Project	IEEE 802.16 Broadband Wireless Access Working Group < http://ieee802.org/16 >	
Title	Clarification of renumbering and permutation based on DL_PermBase parameter	
Date Submitted	2005-05-05	
Source(s)	Sean Cai Jason Hou LiuJun Hu	scai@ztesandiego.com jhou@ztesandiego.com
	ZTE San Diego Inc. 10105 Pacific Heights Blvd. San Diego, CA 92121 USA	Voice: 858-554-0387 Fax: 858-554-0894
	Lei Wang Cygnus Multimedia Communications, Inc.	lwang@cygnuscom.com Voice (760)448-1984 Fax: (760)448-1989
	Yigal Leiba Yossi Segal Runcom Ltd.	yigall@runcom.co.il Voice:+972-3-9528440 Fax:+972-3-9528805
Re:	IEEE 802.16 WG Recirculation Ballot #17a on P802.16-2004/Cor1/D2	
Abstract	This contribution is for clarification of renumbering and permutation based on DL_PermBase parameter	
Purpose	To incorporate the text modification proposed in this contribution into P802.16-2004/Cor1/D3.	
Notice	This document has been prepared to assist IEEE 802.16. It is offered as a basis for discussion and is not binding on the contributing individual(s) or organization(s). The material in this document is subject to change in form and content after further study. The contributor(s) reserve(s) the right to add, amend or

Figure 219-Illustration of OFDMA frame with multiple zones

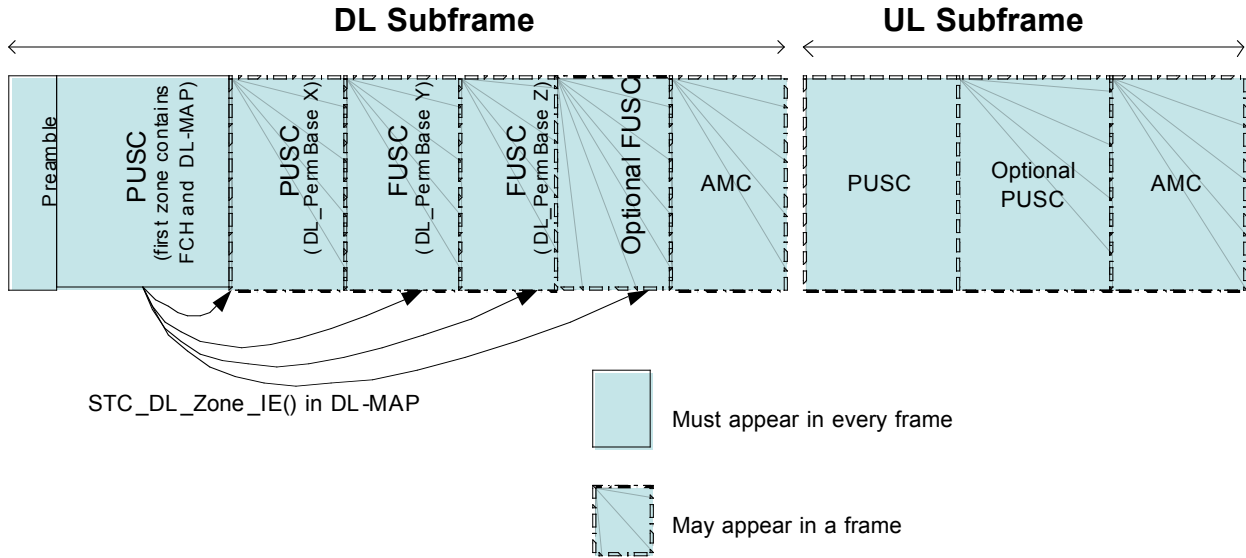
In the DL-MAP, a BS may transmit DIUC = 15 with the TDSTC_DL_ZONE_IE() to indicate that the subsequent allocations shall use a specific permutation, or be transmit diversitySTC encoded. The downlink frame shall start in PUSC mode with ~~IDcellDL_PermBase = 0 and~~ no transmit diversity. Allocations

[Replace Figure 219 with the following figure:]
